FOWL RIVER PRESERVE SUBDIVISION

APPLICATION NUMBER 23 DATE October 3, 2013

REQUEST Subdivision

SITE PLAN

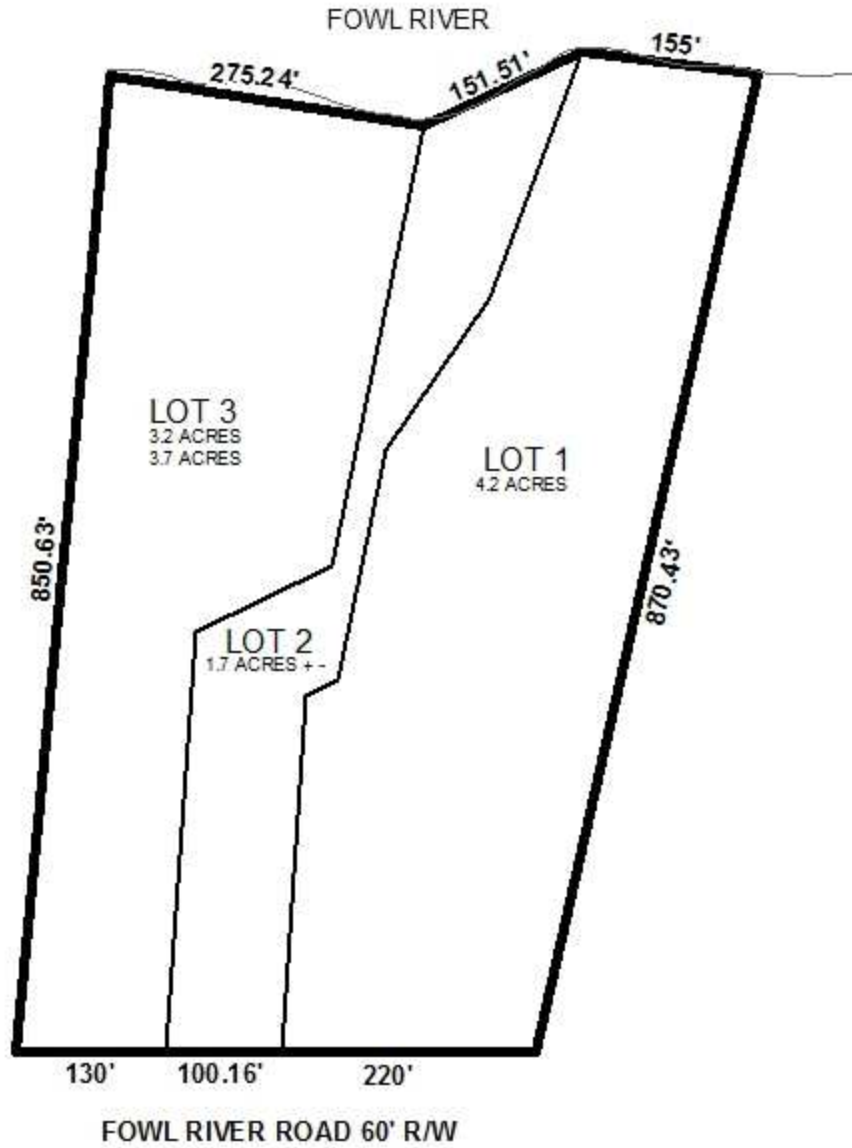
The proposed lots meet the minimum size and frontage requirements as regulated by Section V.D.2. of the Subdivision Regulations. However, these lots do not comply with Section V.D.3. of the Subdivision Regulations regarding maximum depth. Thus, a waiver will be required in order to approve the subdivision as proposed.

Both proposed Lots 1 and 2 appear to be irregular shaped lots and no justification was provided. The proposed Lot 3 is a flag lot, and, while meeting the minimum width of 25 feet for a flag lot, the applicant did not provide any information stating whether or not this was a family subdivision or any information detailing any unusual circumstance which may exist on the lot. As such, the proposed lot does not seem to satisfy the requirements of Section V.D.1. of the Subdivision Regulations.

The proposed lots have frontage along Fowl River Road, a minor street not provided with curb and gutter. The existing right-of-way is depicted as being 60 feet which is in compliance with Section V.B.14. of the Subdivision Regulations. Each proposed lot should be limited to one curb-cut to Fowl River Road with size, location and design to be approved by Mobile County Engineering.

The 25-foot minimum building setback is not shown on the plat. Revision should be made to the final plat to depict the 25-foot minimum building setback line and the lot size in square feet.

- 1) the proposed lots 1, 2 and 3 do not comply with Section V.D.3. of the Subdivision Regulations regarding maximum depth; and
- 2) the proposed lots 2 and 3 do not comply with Section V.D.1. of the Subdivision Regulations regarding size and shape of lots, and no justification has been provided.
